**PLANNING COMMISSION
SITE PLAN COMPATIBILITY WAIVER REQUEST REVIEW SHEET**

CASE: SPC-2016-0201DT

PROJECT NAME: 4809 ½ Burnet Road

CASE#: SPC-2016-0201DT
 ADDRESS: 4809 1/2 Burnet Rd
 CASE NAME: Grover Parking
 MANAGER: Christine Barton-Holmes

SITE PLAN

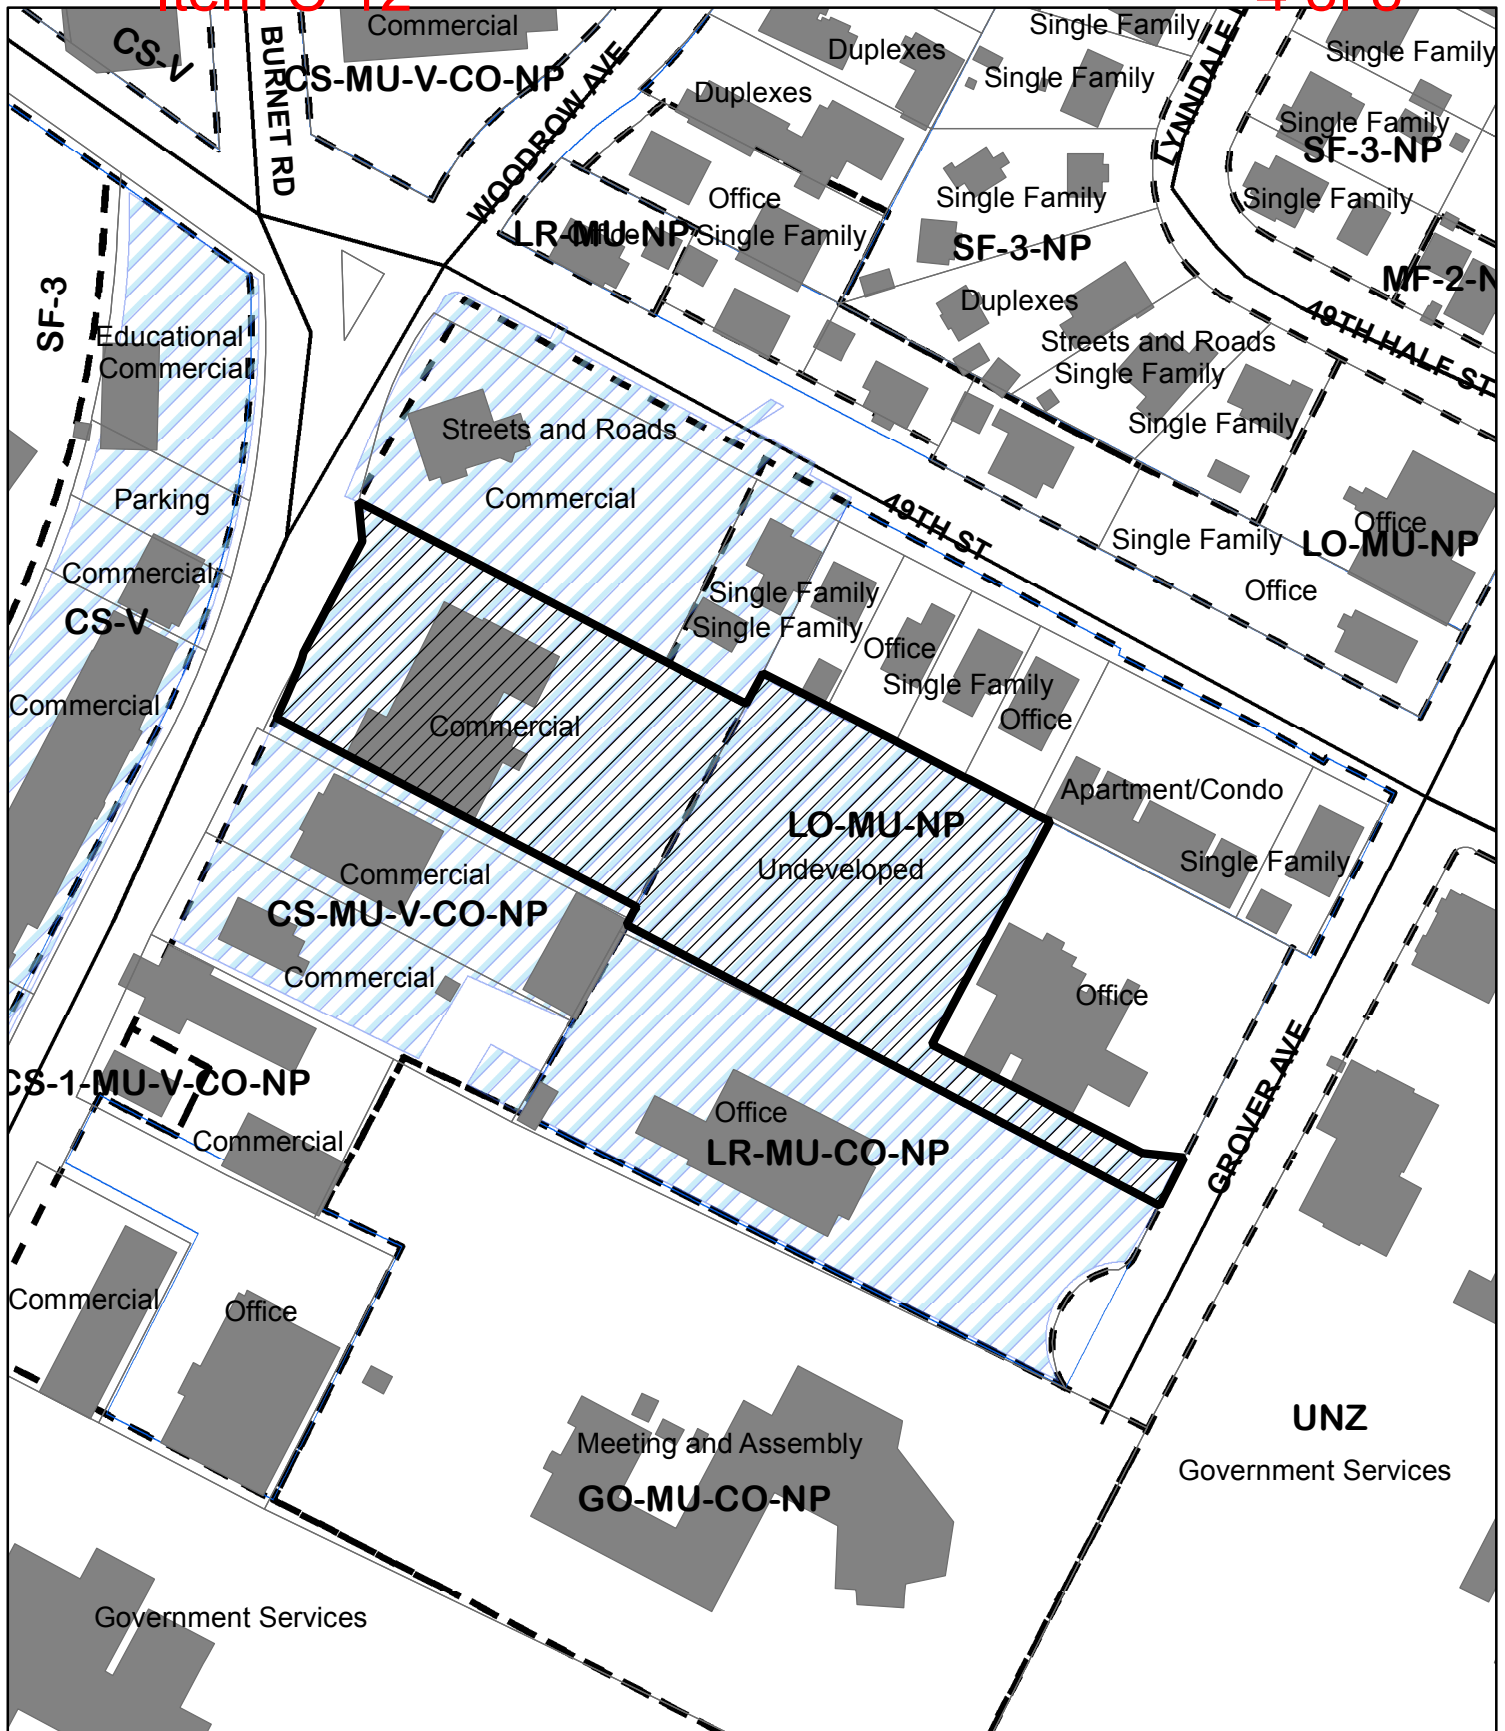
The applicant requests a waiver from a 25-foot compatibility setback to an approximately 7.5-foot compatibility setback for a parking lot. The site is adjacent to single-family residential to the north, a preschool to the east, retail commercial to the west, and a financial institution to the south. The reduced setback is along the rear of the preschool and is screened by a 6'-tall wooden privacy fence.

Land Use: The applicant is requesting a waiver from Compatibility standards to reduce the setback for the offsite parking from 25 feet to approximately 7.5 feet along the east property line. The offsite parking is proposed to augment existing parking for the commercial retail center, which includes several restaurants, at 4801-4809 Burnet Road. Access will be from Burnet Road, with a delineated pedestrian walkway, and from an existing driveway connecting to Grover Avenue. The parking lot will be fully screened with fencing and landscaping, and will comply with all applicable regulations upon site plan approval.

Staff recommends approval of the waiver from LDC Section 25-2-1067 to reduce the Compatibility driveway setback requirement from 25 feet to approximately 7.5 feet from adjacent LO-MU-NP- zoned property used as single family.

DIMENSIONED SITE PLAN

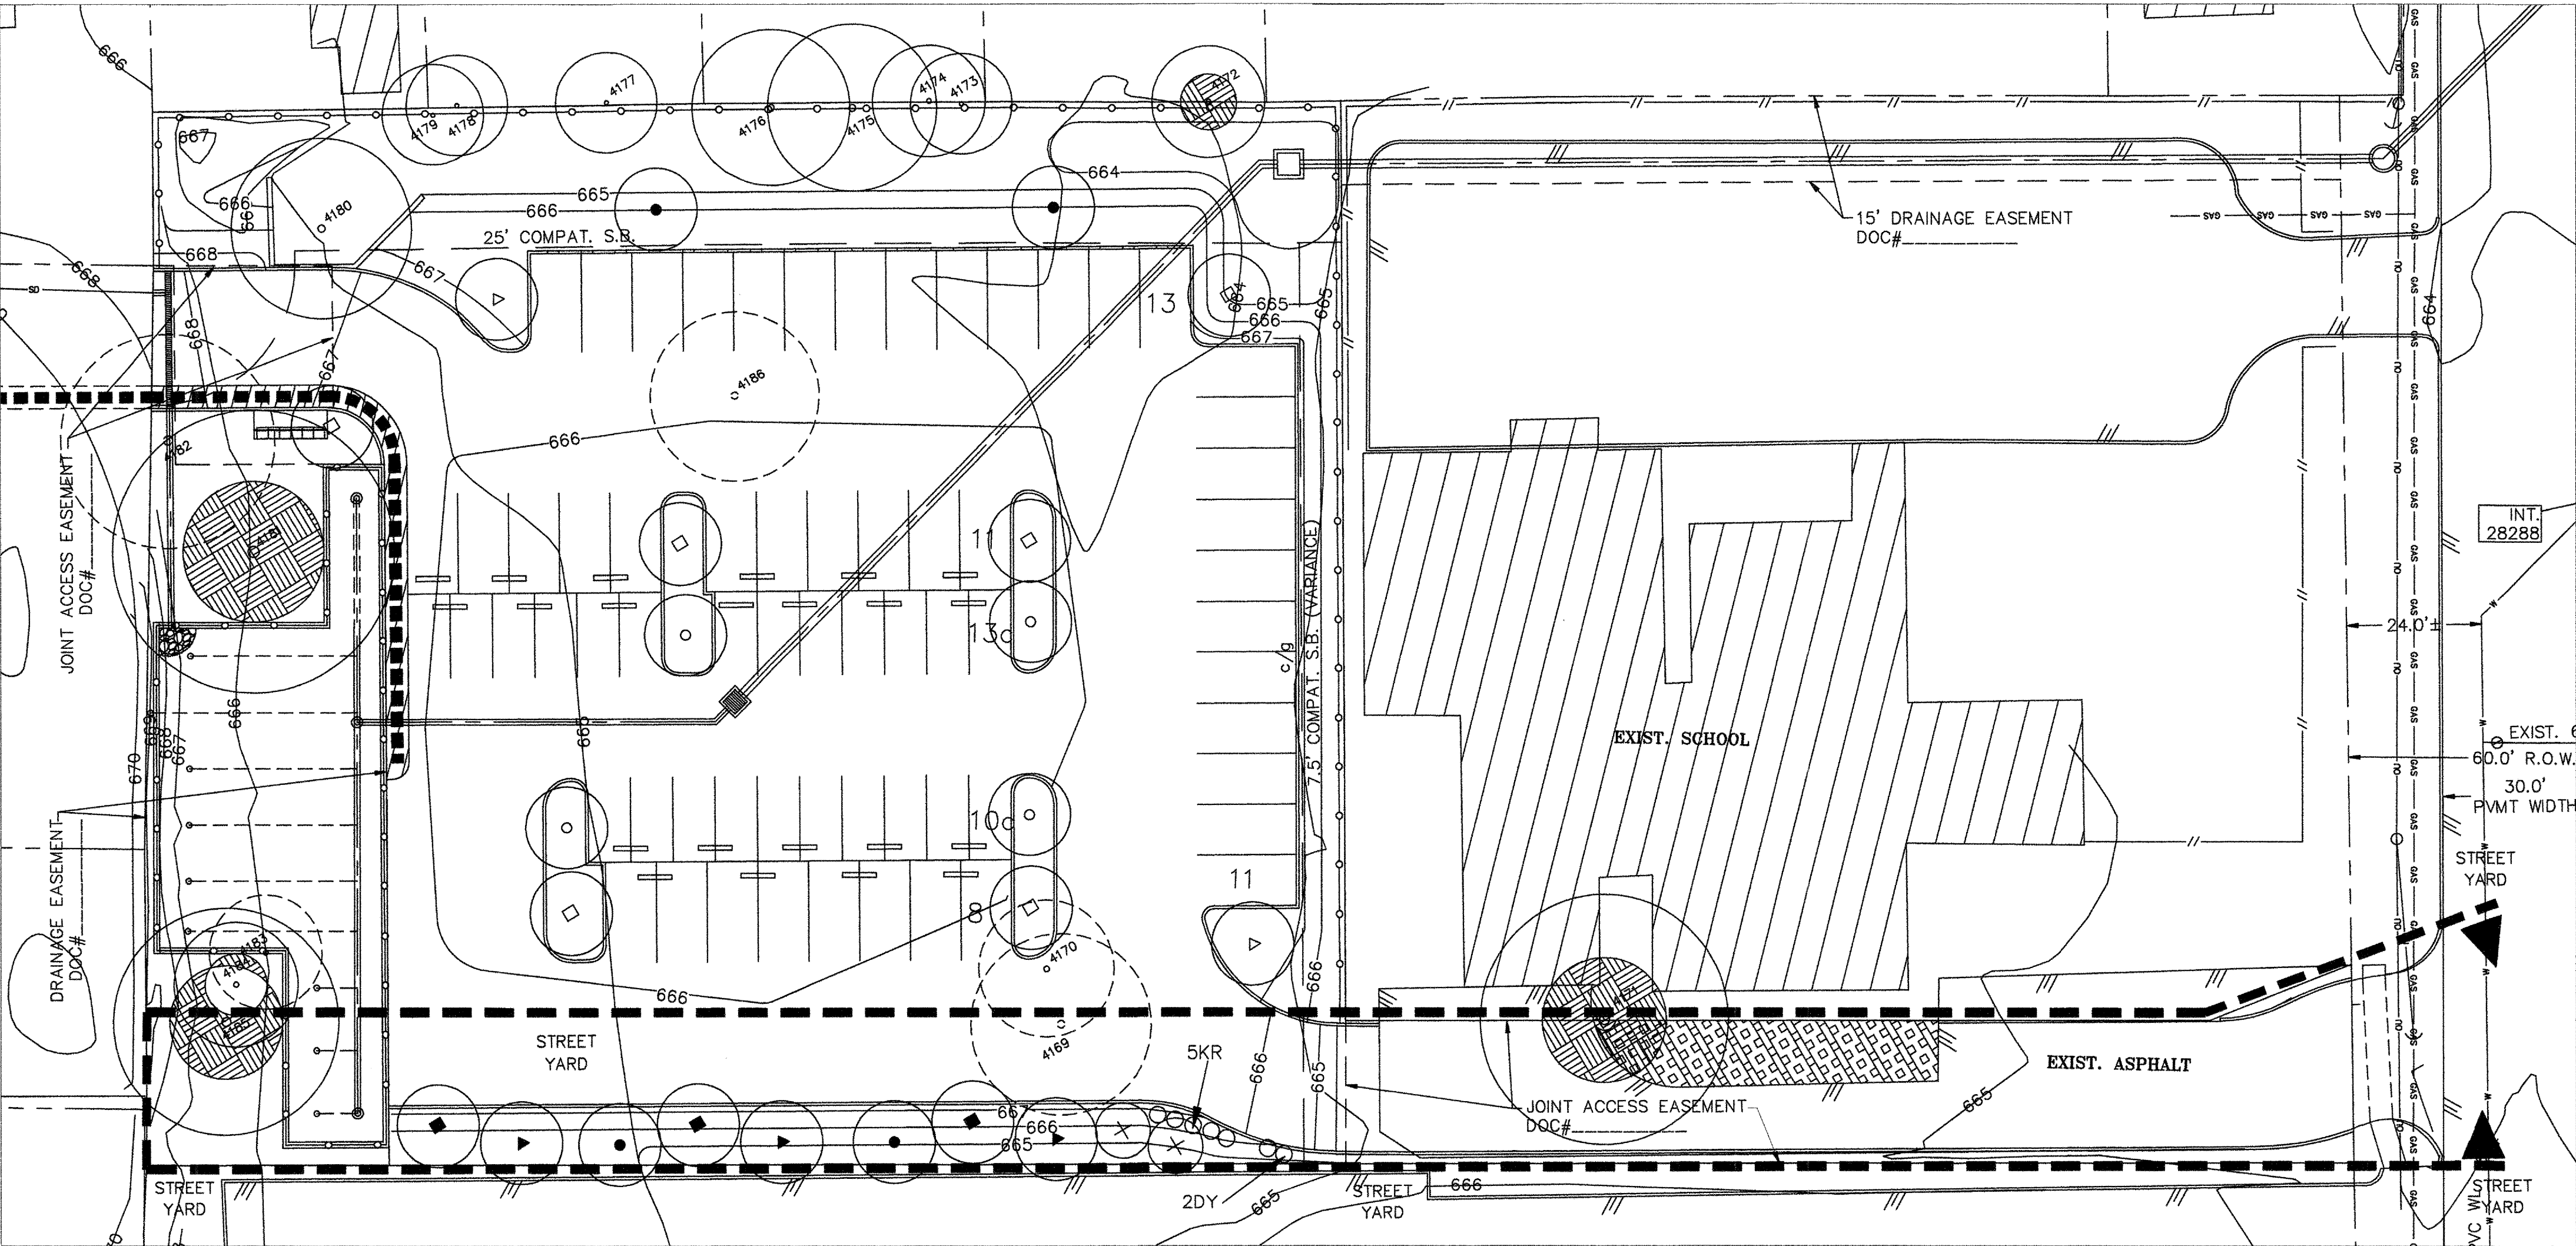
COMPATIBILITY SETBACK WAIVER NOTE:
A WAIVER FROM THE COMPATIBILITY SETBACK WAS APPROVED FOR THIS SITE ON _____ FROM EAST PROPERTY LINE.
